Intersection ID: 1003042	Main Street: AMBER_MEADOWS_DR	Cross Street: GLENOLDEN_DR	Location:	NW
ADA ID: 9D58EBD66755	Ramp Type: Perp	Initial Pass/Fail: Fail	Overall Compliance: No	Severity Score: 21.25

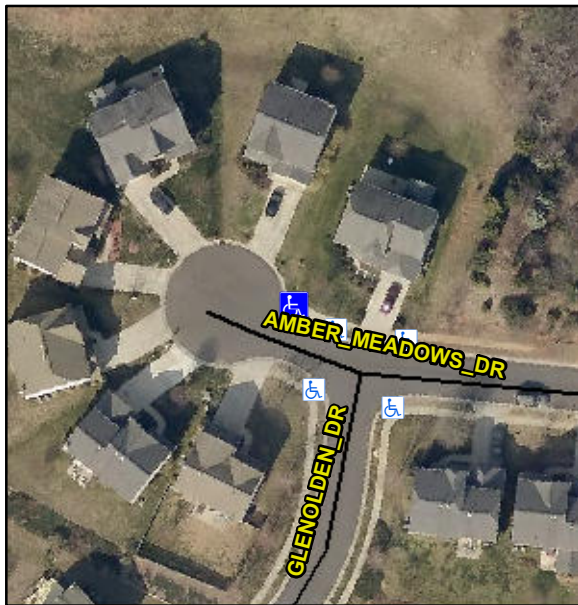
Not Found, R304.5.1, R304.2.2

Possible Solutions:			Compliance	Description	Data	Compliance	Description	Data
Remove & Replace Entire Ramp.			N/A	Ramp Length (in)	47.0	No	Ramp Slope (%)	9.3
			No	Ramp Width (in)	47.0	Yes	Ramp XSlope (%)	1.0
			N/A	Flare Type LT	N/A	N/A	Flare Type RT	N/A
			N/A	Flare Slope LT (%)	N/A	N/A	Flare Slope RT (%)	N/A
			N/A	Flare Traversable LT?	N/A	N/A	Flare Traversable RT?	N/A
			N/A	Landing Length (in)	N/A	N/A	DWS Provided?	N/A
			N/A	Landing Width (in)	N/A	N/A	DWS Contrast?	N/A
			N/A	Landing Slope (%)	N/A	N/A	DWS Length (in)	N/A
			N/A	Landing X Slope (%)	N/A	N/A	DWS Full Width?	N/A
			N/A	Landing Curb? (Y/N)	N/A	N/A	DWS Offset (in)	N/A
Surveyor Notes:			N/A	Shared Landing?	N/A			
Not Found, R304.5.1, R304.2.2			N/A	Gutter Ponding?	N/A	N/A	Gutter Slope (%)	N/A
			N/A	Gutter Lip Ht (in)	N/A	N/A	Gutter X Slope (%)	N/A
			N/A	Painted X Walk1?	No	N/A	Painted X Walk2?	N/A
				X Walk 1 Direction	To SW		X Walk 2 Direction	N/A

Remove & Replace Entire Ramp.
